NEW MEXICO OIL CONSERVATION DIVISION
 - Engineering Bureau -
 1220 South St. Francis Drive, Santa Fe, NM 87505

RE: Administrative Order SWD-1319
February 28, 2012
BEU Hackberry 34 Federal SWD #1
30-015-40288
UL A; NENE; Sec. 34, T19S, R31E
800' FNL 825' FEL;
Eddy County, New Mexico

BOPCO, L.P. would like to amend the SWD permit, SWD-1319 dated February 28, 2012. After drilling the well a couple of the depths have changed to what was permitted.

BIG EDDY UNIT
Zero AOR wells
5 AOR AFFECTED PERSONS "
→ REVISION TO SWD-1319
TO REFLECT ACTUAL DEPTHS

CURRENT WELLBORE DIAGRAM

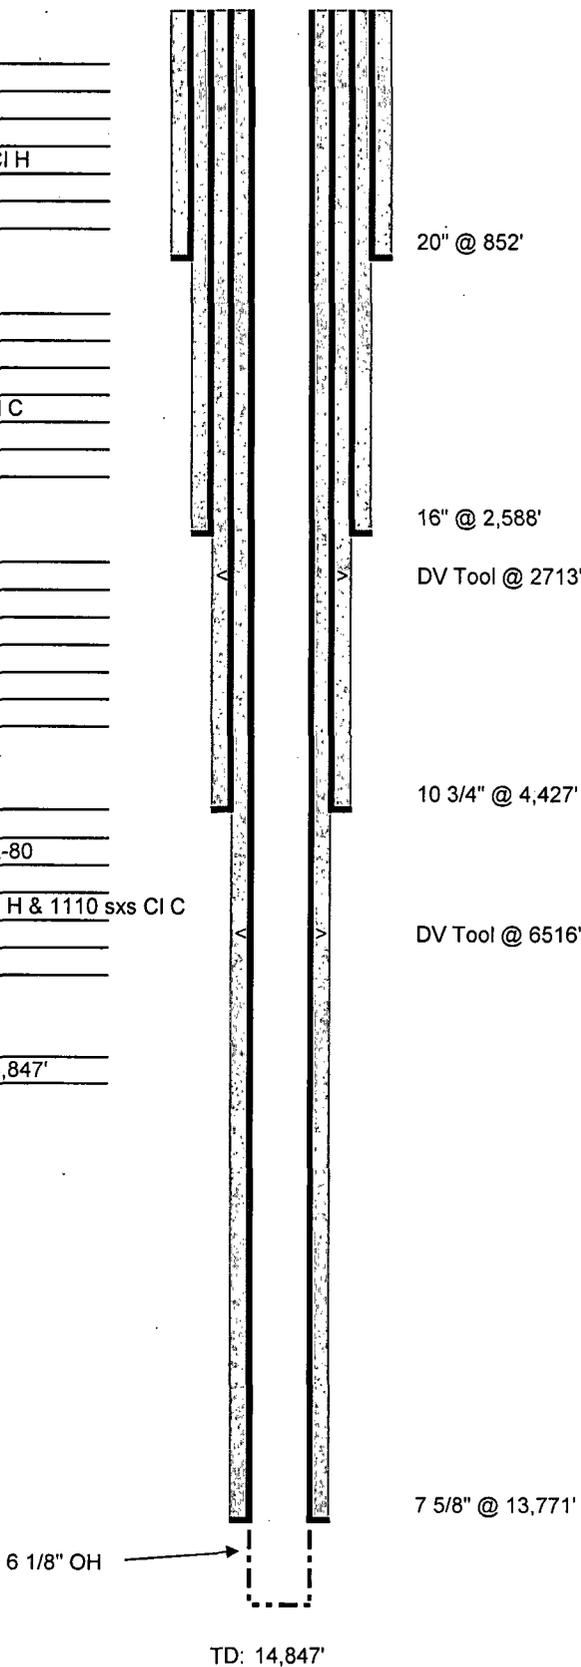
The well was drilled to a depth of **14,847'** and not 14,500. This would make our permitted disposal interval **13,755 to 14,847** and not 13,755 to 14,500'. The packer is set at 13,720' which would be 35' above the permitted interval of 13,755. The well has not commenced injection.

Attached please find an updated wellbore diagram. A completion report (3160-4) will be filed within the next week to the BLM.

Sandra – please send an updated wellbore diagram showing the new depths (and put formation tops on it also) and a cover letter asking for the amended permit. The cover letter should have the operator name of this well, operators address, the well name and API number, reference the existing permit number, etc. – everything I would need to issue an amended permit. Please incorporate the geologists comments in the cover letter about productivity, probable top of the Devonian and Montoya formations, etc.

Size: 7 5/8"
 Wt: 39#
 Grd: L-80 & HCL-80
 Set @: 13,771'
 Sxs Cmt: 2170 sxs CI H & 1110 sxs CI C
 TOC: Surface
 Hole Size: 9 7/8"

Size: 6 1/8"
 Depth: 13,771' - 14,847'

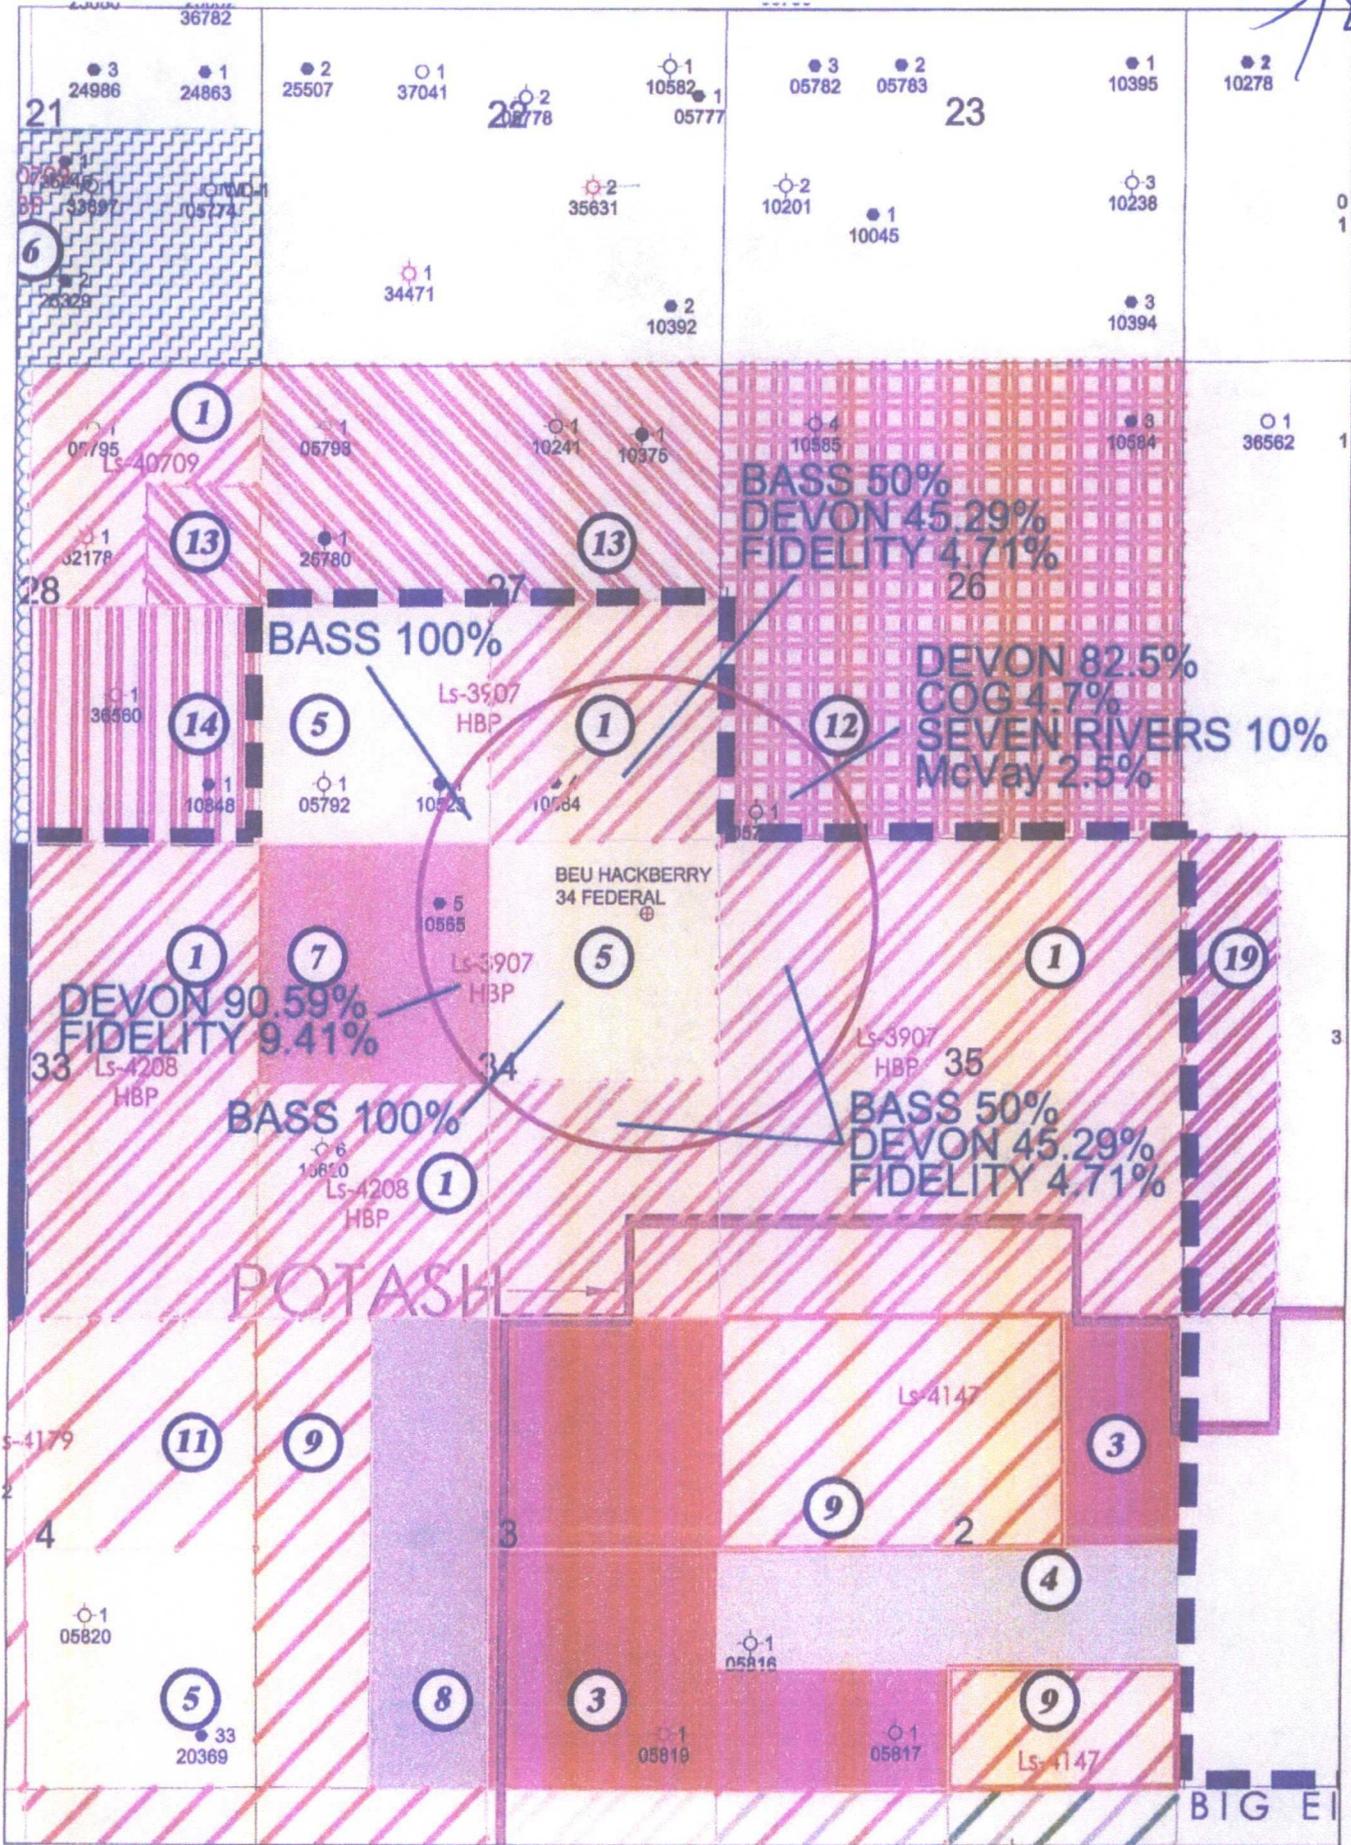
Is the Devonian on any structure or closure in this area? Is there any regional structure map of the Devonian – send a copy if you can generate one.

No, the Devonian is not on a closed structure at this location.
